# Access Compliance Report

## Public Rights-of-Way

Intersection ID: 44704	Main Street: MARY_BLAIR_LN	Cross Street: PATRIOTS_POINT_LN	Location: S
ADA ID: E406441893CB	Ramp Type: Perp	Initial Pass/Fail: Fail	Overall Compliance: No
		Severity Score: 10

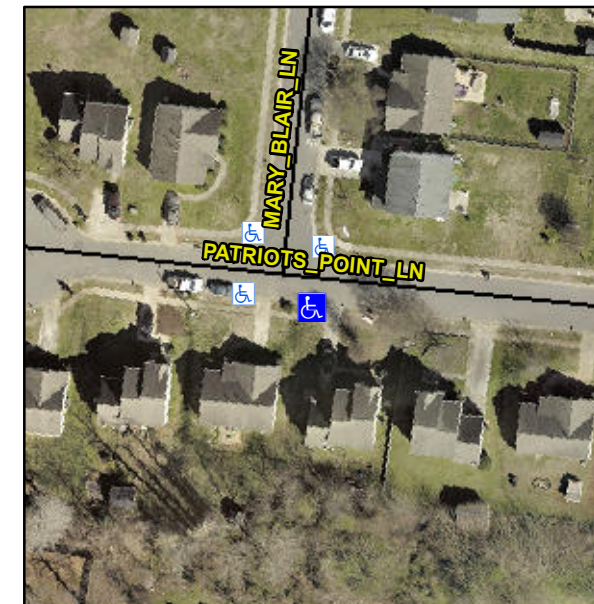
**Not Found, R304.5.1, R304.5.3**

Compliance	Description	Data	Compliance	Description	Data
N/A	Ramp Length (in)	47.0	Yes	Ramp Slope (%)	5.1
No	Ramp Width (in)	37.0	No	Ramp XSlope (%)	3.5
N/A	Flare Type LT	N/A	N/A	Flare Type RT	N/A
N/A	Flare Slope LT (%)	N/A	N/A	Flare Slope RT (%)	N/A
N/A	Flare Traversable LT?	N/A	N/A	Flare Traversable RT?	N/A
N/A	Landing Length (in)	N/A	N/A	DWS Provided?	N/A
N/A	Landing Width (in)	N/A	N/A	DWS Contrast?	N/A
N/A	Landing Slope (%)	N/A	N/A	DWS Length (in)	N/A
N/A	Landing X Slope (%)	N/A	N/A	DWS Full Width?	N/A
N/A	Landing Curb? (Y/N)	N/A	N/A	DWS Offset (in)	N/A
N/A	Shared Landing?	N/A			
N/A	Gutter Ponding?	N/A	N/A	Gutter Slope (%)	N/A
N/A	Gutter Lip Ht (in)	0.8	N/A	Gutter X Slope (%)	N/A
N/A	Painted X Walk1?	No	N/A	Painted X Walk2?	N/A
	X Walk 1 Direction	To N		X Walk 2 Direction	N/A
N/A	X Walk 1 Width (in)	N/A	N/A	X Walk 2 Width (in)	N/A
	X Walk 1 Slope (%)	0.9		X Walk 2 Slope (%)	N/A
	X Walk 1 X Slope (%)	2.9		X Walk 2 X Slope (%)	N/A

**Remove & Replace Entire Ramp.**
